Notice of Allowability	Application No.	Applicant(s)	
	10/067,351	SIMARD ET AL.	
	Examiner	Art Unit	
	David S. Kim	2613

EXAMINER'S AMENDMENT

Figure 1A

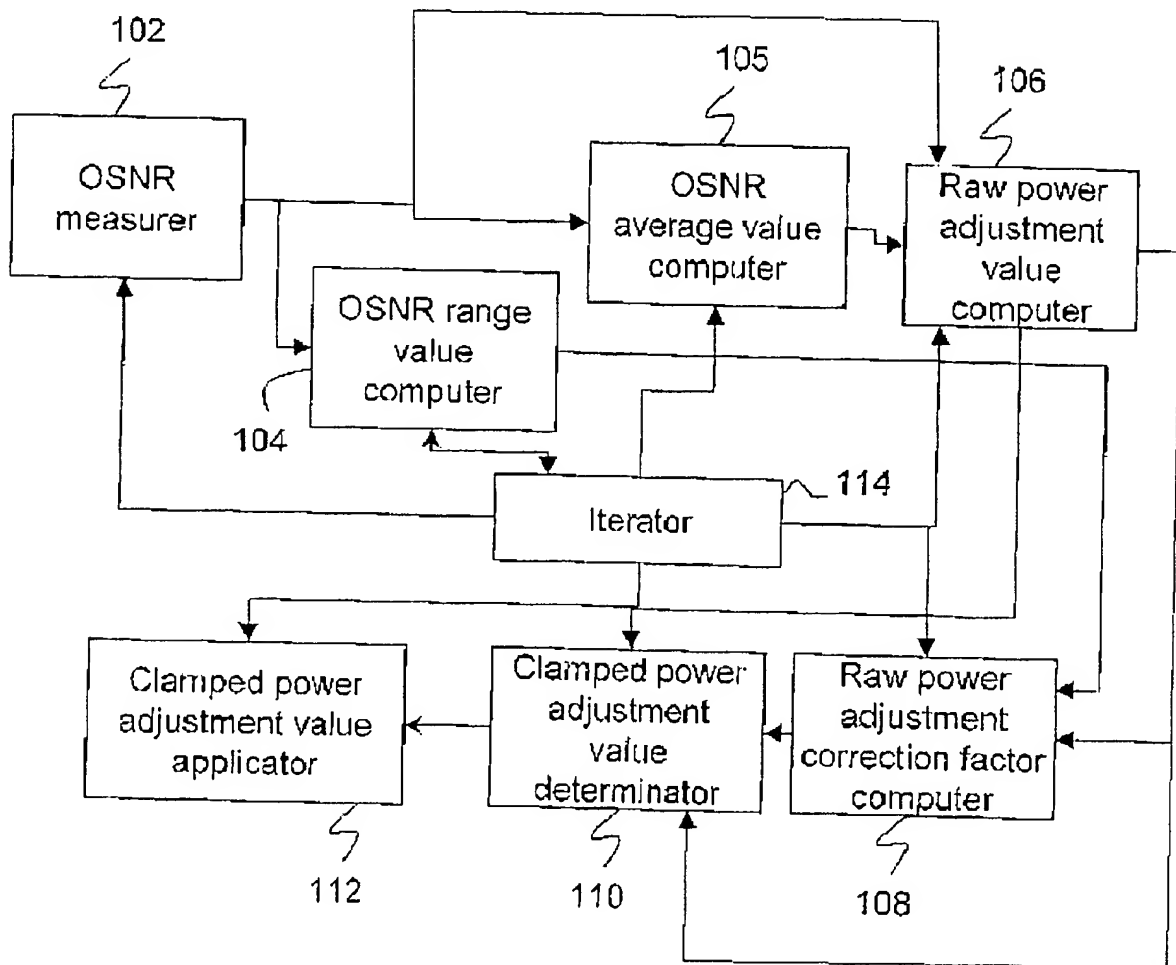
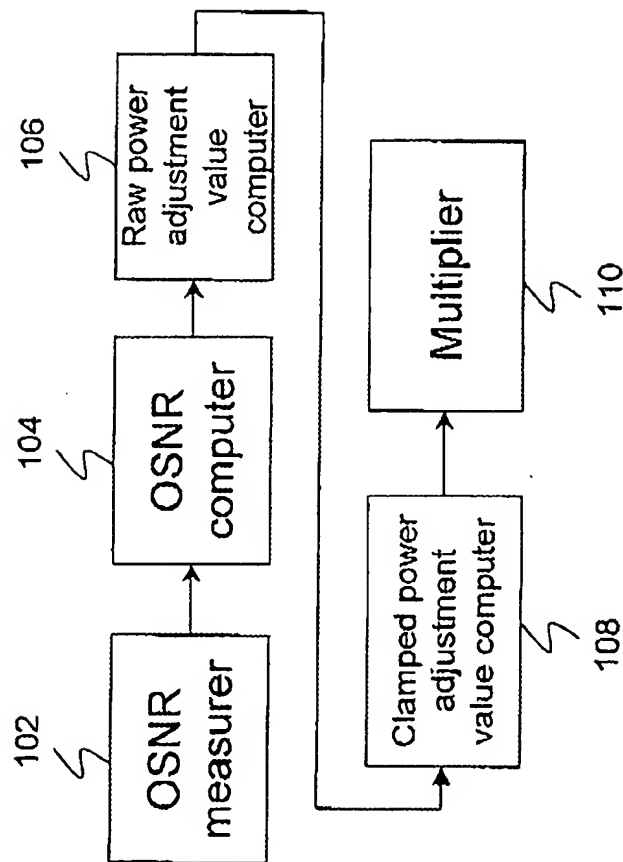
2. Applicant's compliance with the objections to the drawings in the previous Office Action (mailed on 20 March 2006) is noted and appreciated. Applicant responded by filing a new drawing, Fig. 1A, on 20 June 2006. This drawing is disapproved. Accordingly, it is not entered.

- Fig. 1A shows one unit, OSNR computer 104, as the means for computing (ii) and the means for computing (iii) in claim 3. However, the rest of the specification does not support/disclose the use of **one** unit as the means for computing (ii) **and** the means for computing (iii) in claim 3.
- Fig. 1A labels unit 108 as a "Clamped power adjustment value computer" where the corresponding specification states that it should read "Raw power adjustment correction factor computer" (filed on 20 June 2006, see the amendment to the specification on p. 3)
- The following means from claim 3 are not shown in Fig. 1A (nor in the other figures): the means for applying (vii) and the means for iterating (viii).
- The following means from claim 4 are not shown in Fig. 1A (nor in the other figures): the means for determining and the means for dividing.

3. The following changes to the drawings have been approved by the examiner and agreed upon by applicant:

Amend Fig. 1A to more closely match the following suggested diagram:

Figure 1B

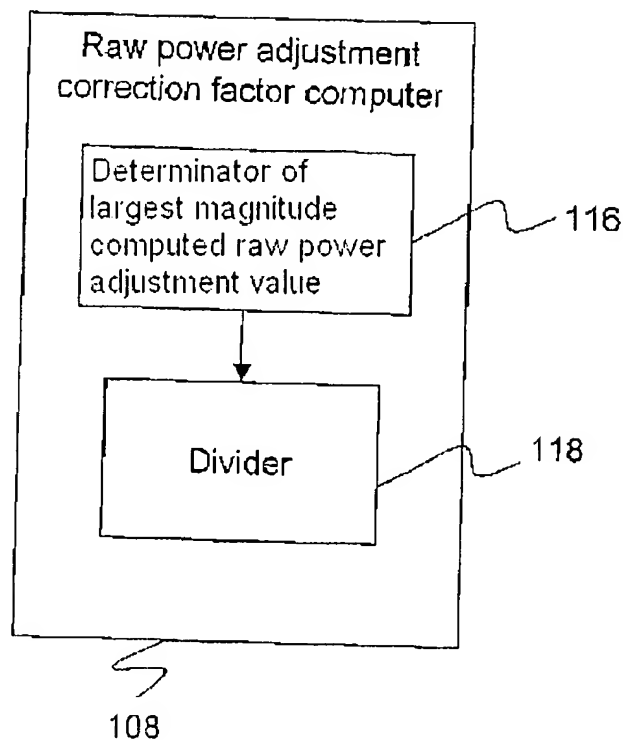
Add a new Fig. 1B to closely match the following suggested diagram:

In order to avoid abandonment of the application, applicant must make these above agreed upon drawing changes.
